# SHOP DRAWING TRANSMITTAL

Project: Turnbull School Music Room Addition Project No: 1705  
Date: December 21, 2018  
To: TALCO Building Innovations Ltd.  
Attn: Farah Bano (fbano@tal-co.com)  
From: Michelle Cataldo

Shop Drawing Submittal: Division 08 – Windows & Doors  
Submitted by: Alumaticor  
Drawing Title: Alternate Door ThermaPorte 7700 Spec Sheet  
Revision No. N/A  
Dated: December 20, 2018  
Comments:  
Reviewed as noted.

# ThermaPorte 7700

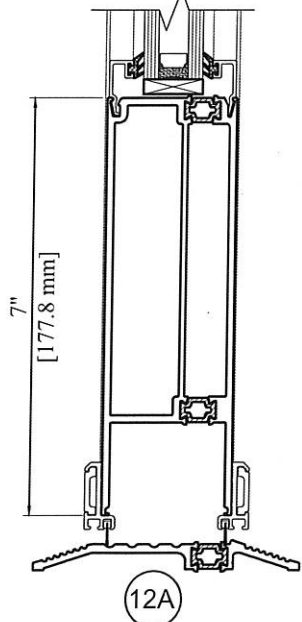
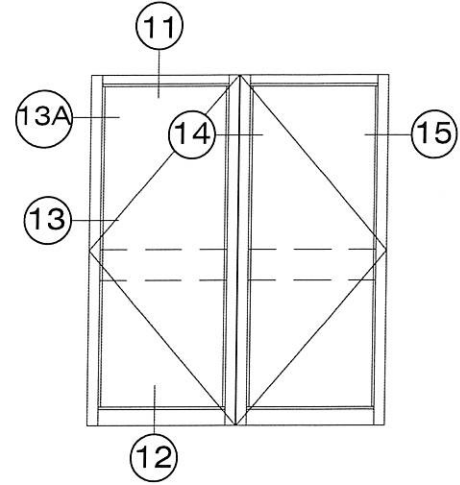
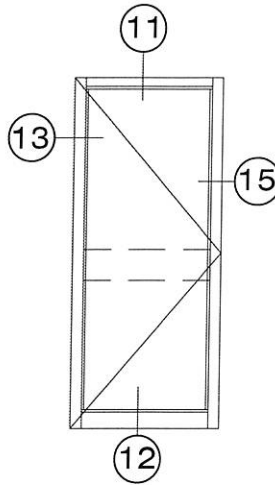
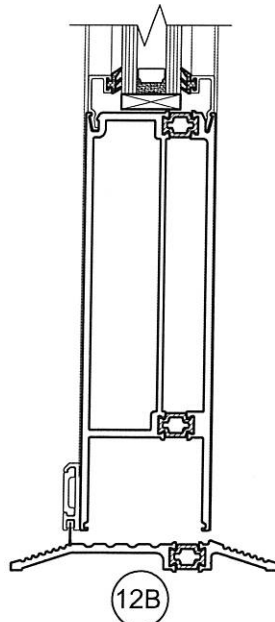
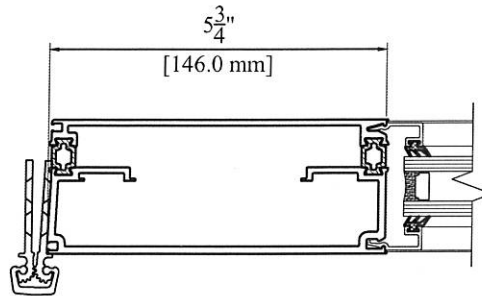
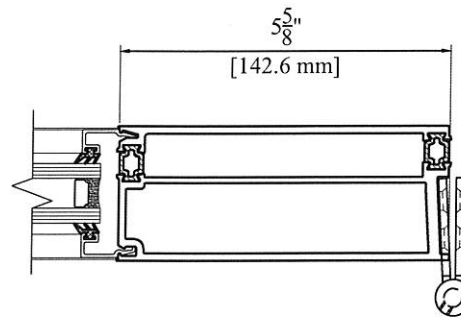
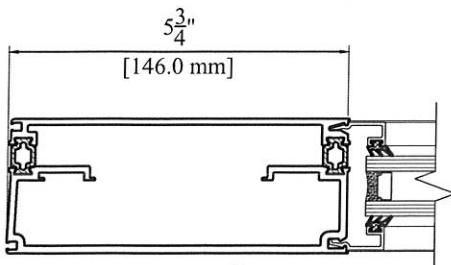
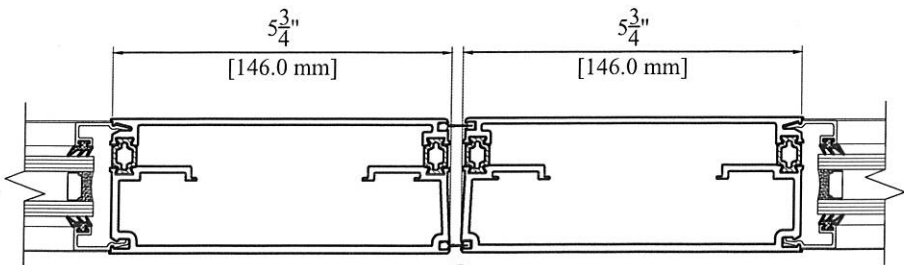
**ALUMINUM SUPPLIER IS RESPONSIBLE FOR COORDINATING HARDWOOD TO SUIT ALTERNATE DOOR.**
